DEPARTMENT OF TRANSPORTATION

Contract #: 04-0120F4Cty: SF/ALA Rte: 80 PM: 13.2/13.9File #: 69.28**WELDING INSPECTION REPORT****Resident Engineer:** Pursell, Gary**Address:** 333 Burma Road**City:** Oakland, CA 94607**Report No:** WIR-007275**Date Inspected:** 08-Jun-2009**Project Name:** SAS Superstructure**OSM Arrival Time:** 700**Prime Contractor:** American Bridge/Fluor Enterprises, a JV**OSM Departure Time:** 1900**Contractor:** Zhenhua Port Machinery Company, Ltd (ZPMC), Changxing Island **Location:** Shanghai, China**CWI Name:** Chen Chih Chien**CWI Present:** Yes No**Inspected CWI report:** Yes No N/A**Rod Oven in Use:** Yes No N/A**Electrode to specification:** Yes No N/A**Weld Procedures Followed:** Yes No N/A**Qualified Welders:** Yes No N/A**Verified Joint Fit-up:** Yes No N/A**Approved Drawings:** Yes No N/A**Approved WPS:** Yes No N/A**Delayed / Cancelled:** Yes No N/A**Bridge No:** 34-0006**Component:** crossbeams and segment 5AE**Summary of Items Observed:**

OBG segment 5AE (Superstructure trial assembly)

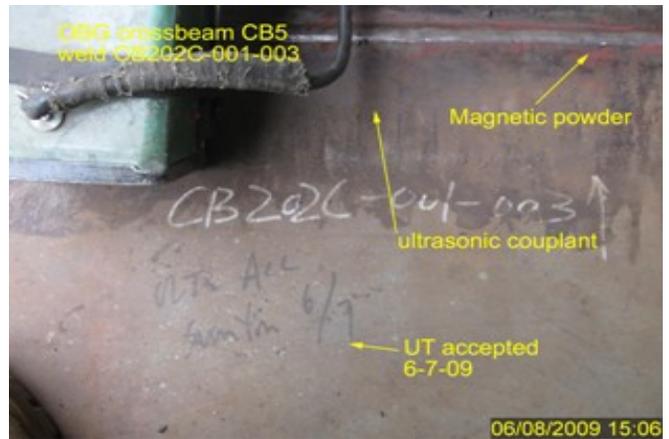
This QA observed cope holes in OBG segment floorbeams that do not appear to comply with the contract documents. These cope holes are located on OBG segment 5AE at or near the intersection of panel point 29 and E4 and at or near the intersection of panel point 29 and E3 where the floorbeam web is welded to the OBG side and bottom panels. (See attached photos for details). AWS D1.5 2002 section 3.2.5 states "Radii of beam copes and weld access holes shall provide a smooth transition, free of notches or cutting past the points of tangency between adjacent surfaces". This QA informed ZPMC QA identified as Mr. Wang Lu and ABF fabrication supervisor identified as Mr. Peter Ferguson that an incident report would be generated for this issue.
